**CORK MAIN DRAINAGE SCHEME**

**ADDENDUM TO**

**ENVIRONMENTAL IMPACT STATEMENT**

**June 1994**

**FIG. 4.5.1(A) LAYOUT PLAN PREFERRED TREATMENT PLANT ON CARRIGRENAN SITE. Scale 1:3000**

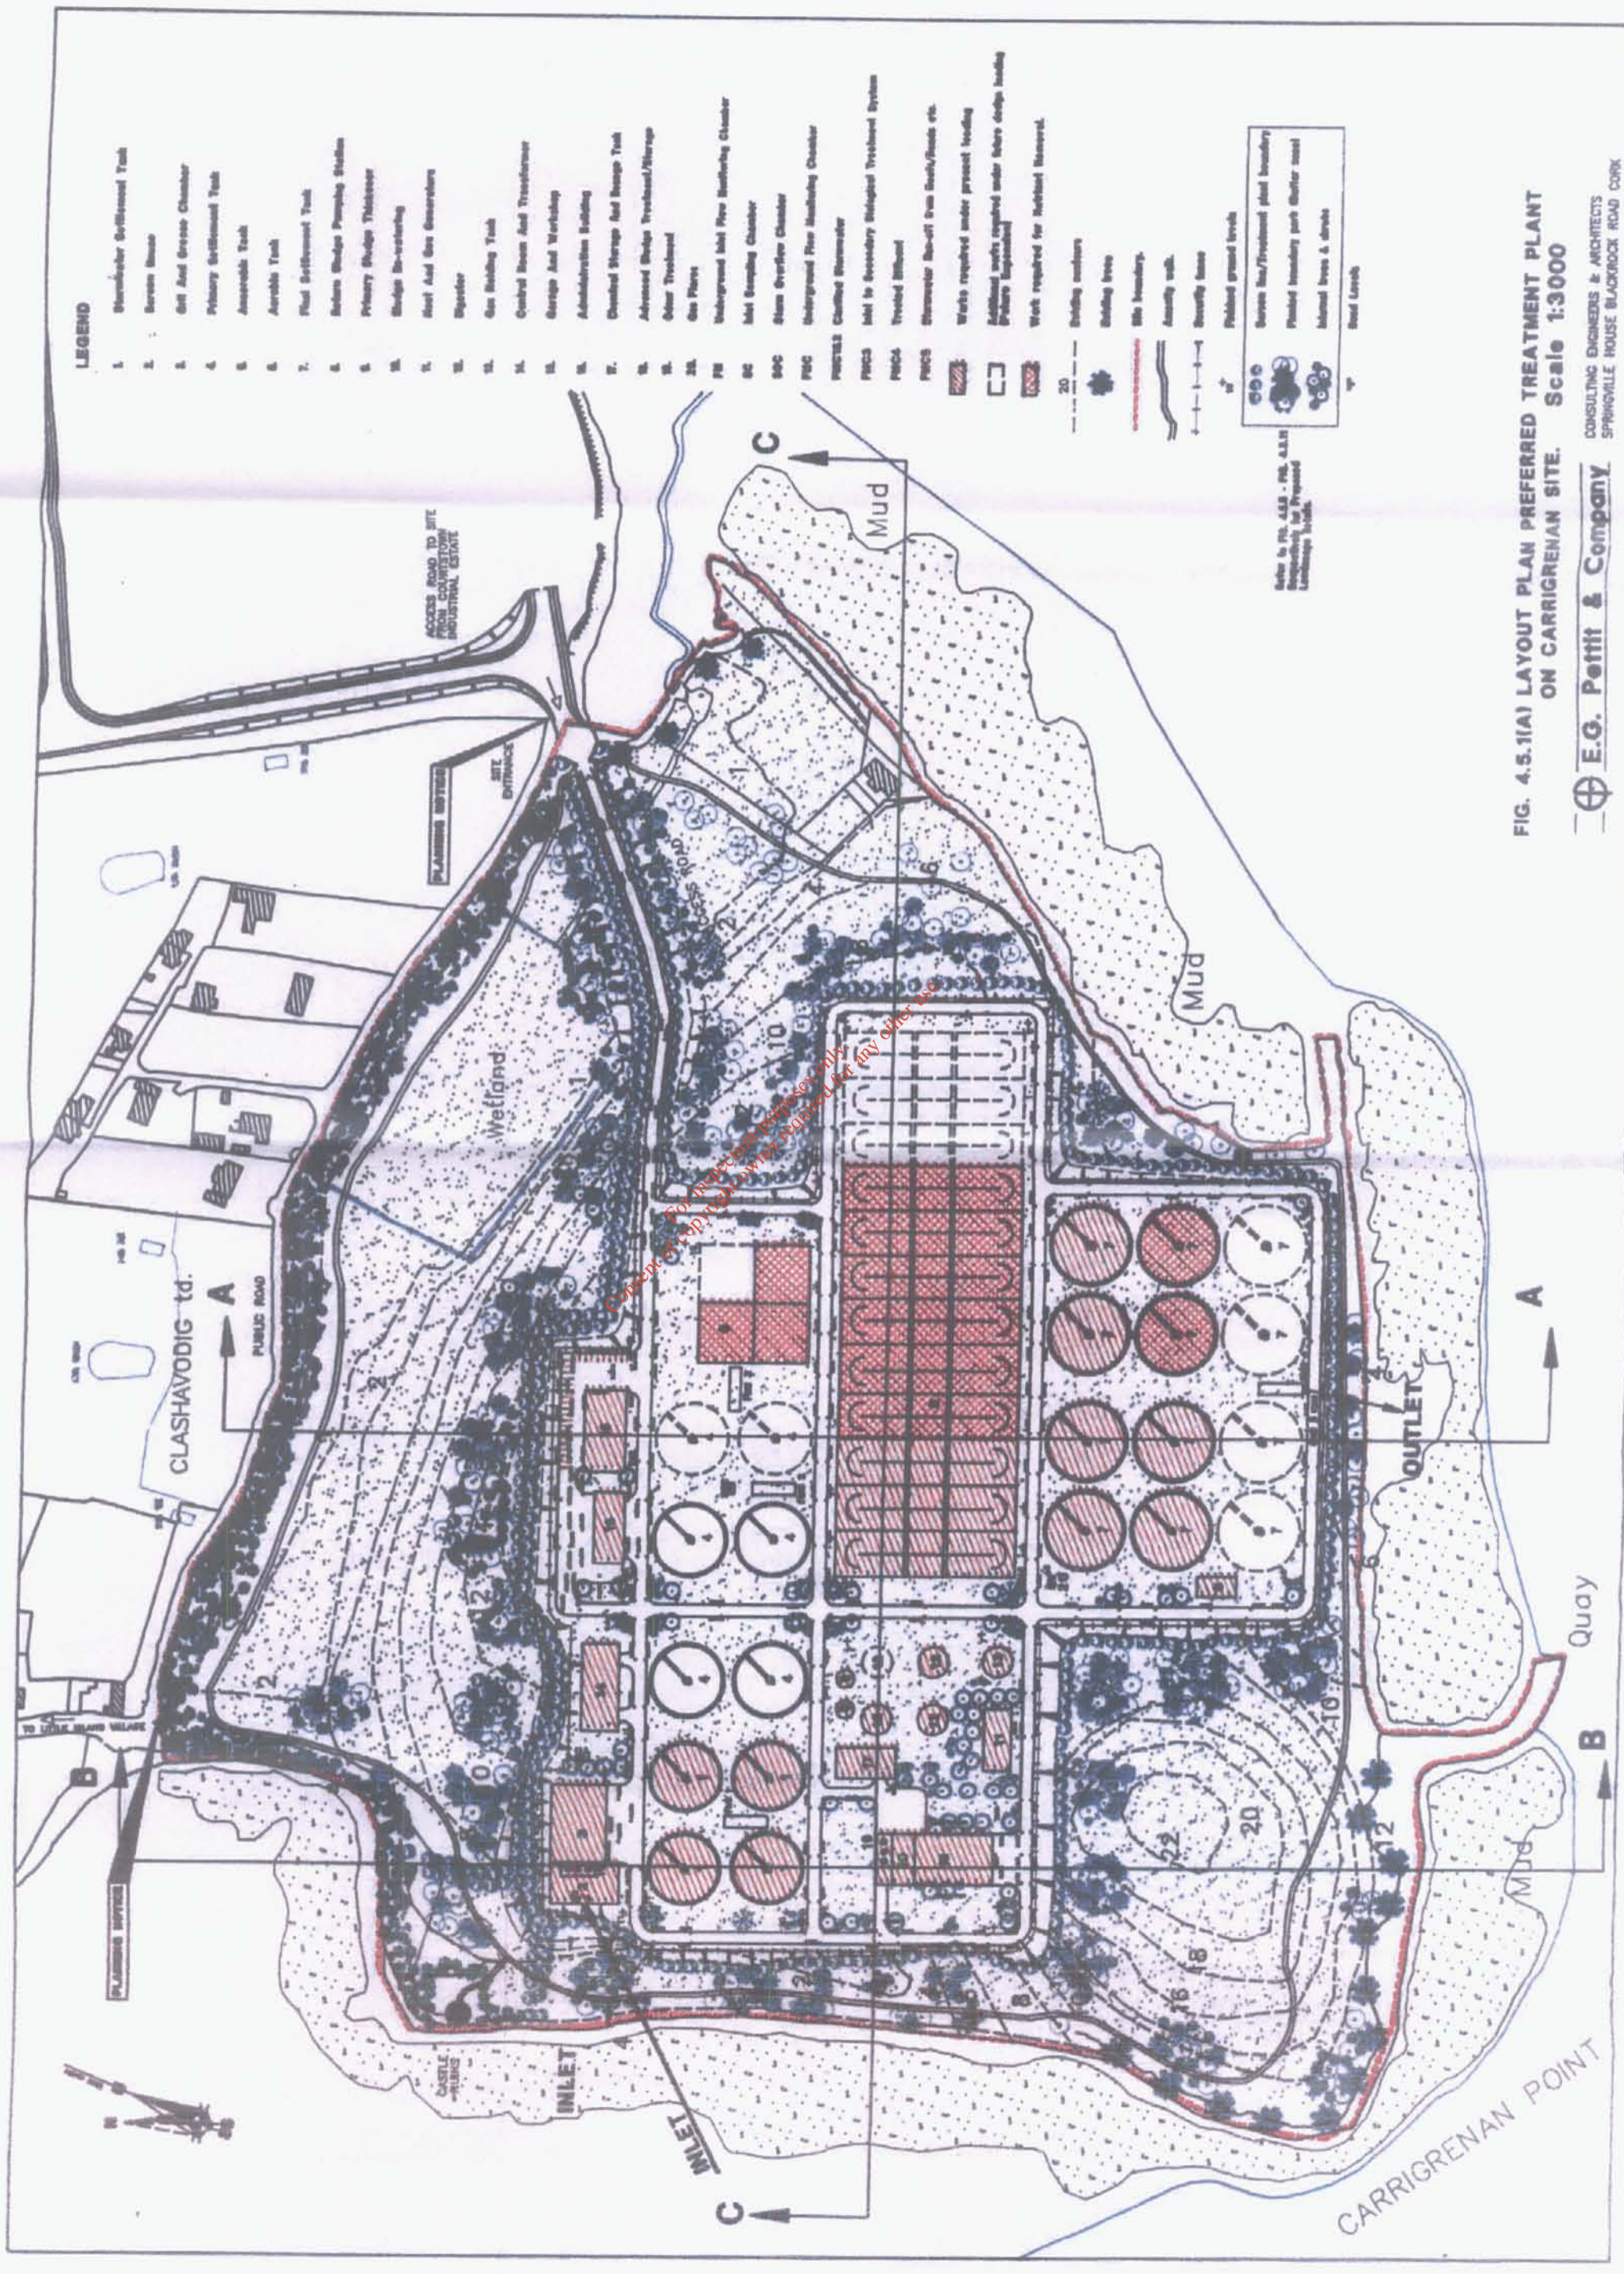
While it is still intended to purchase the entire land bank of 32 hectares in Carrigrenan, it is proposed to reduce the area occupied by the wastewater treatment plant from 20 hectares to 15 hectares. To achieve this the individual plant units have been moved as close as is physically possible to the existing 22 metre high hillock on the southern side of the site (See Fig. 4.5.1(A)). This hillock is the primary topographic feature of the site, providing a natural screen for the proposed wastewater treatment plant when viewed from the southern side of Lough Mahon, and should be retained. The northern screen boundary has also been moved southwards thereby increasing the buffer zone area to the north of the plant. The area of open space reserved on site for amenity purposes represents 53% of the total site area.

An amenity walk, affording public access to the foreshore, will be provided along the shoreline, between the overall (32 ha) site boundary and the secured wastewater treatment plant boundary (See Fig 4.5.1(A)). The walk will be controlled and accessible only during daylight hours and will be tastefully laid out and landscaped (See 2.3 below). It should be noted that currently the public has no formal access to this area.

**LANDSCAPE MASTERPLAN**

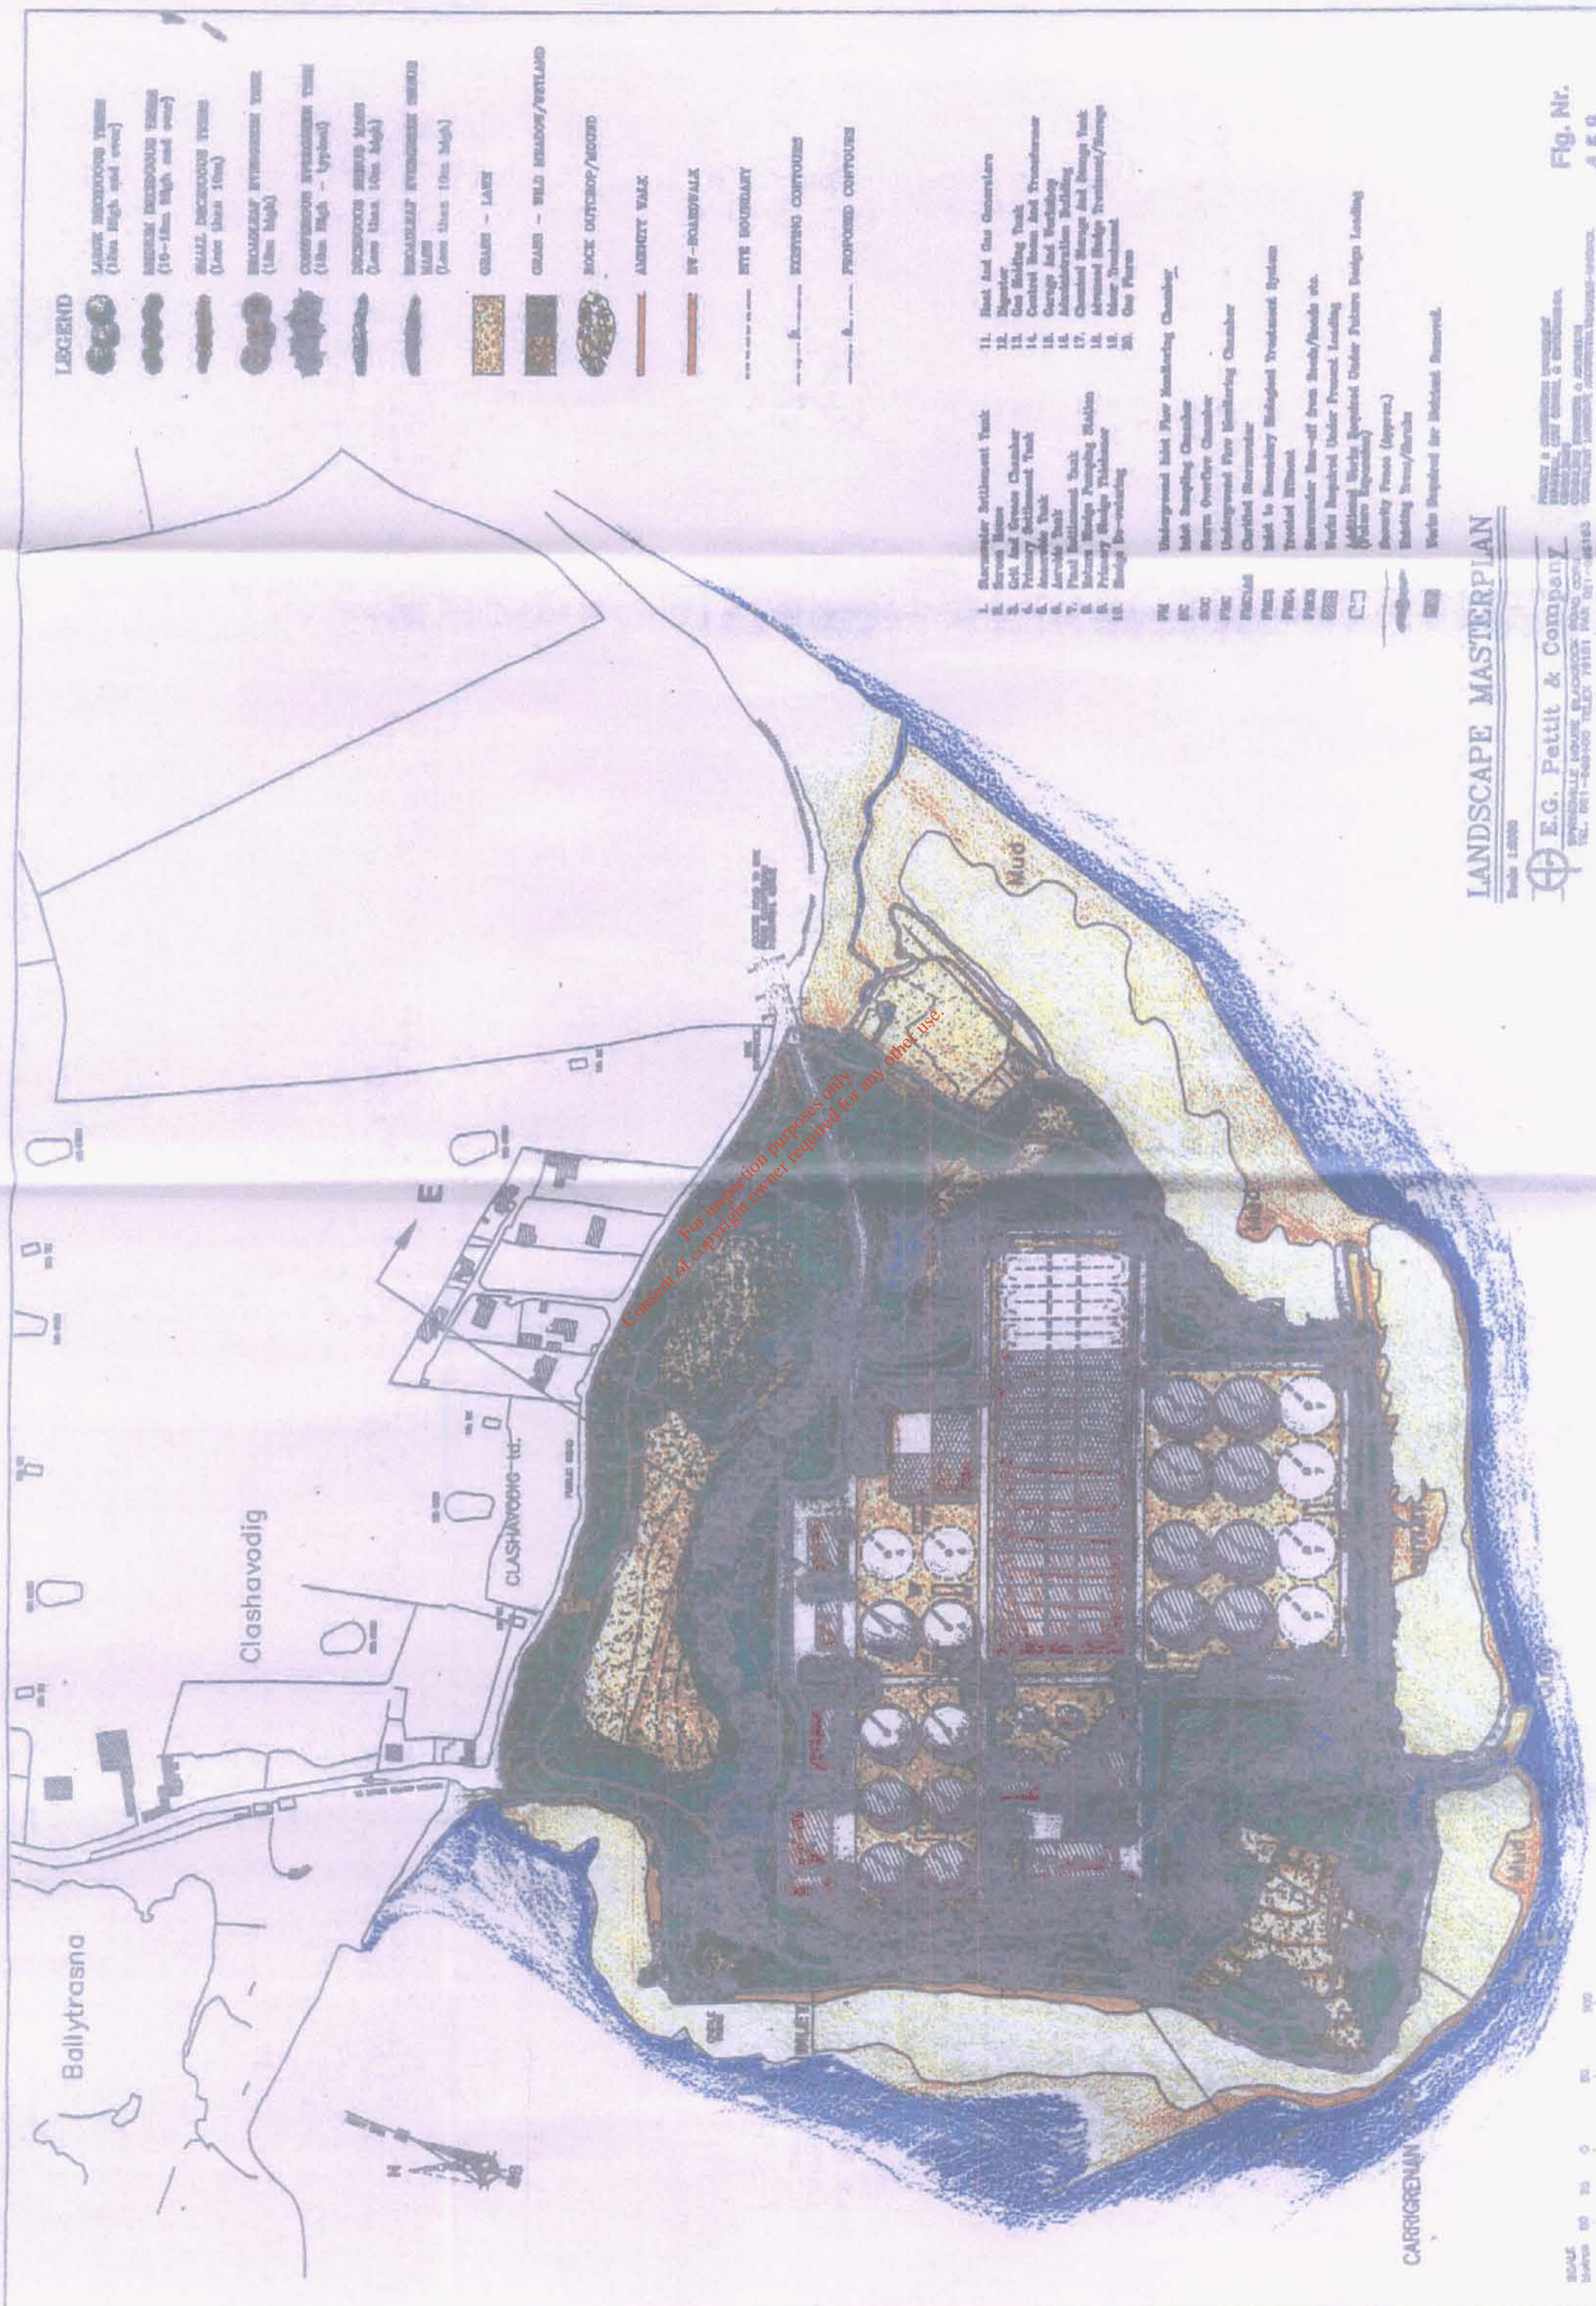
The plant species selected are listed in Appendix 7. The proposed planting concept shows (see Landscape Masterplan Fig 4.5.8) an informal planting layout which acts to buffer and screen the wastewater treatment plant from the surrounding context, and also to ameliorate the loss of mature trees, particularly in the vicinity of Carrigrenan House and at the proposed access to the site, which will be lost due to the construction of the wastewater treatment plant.
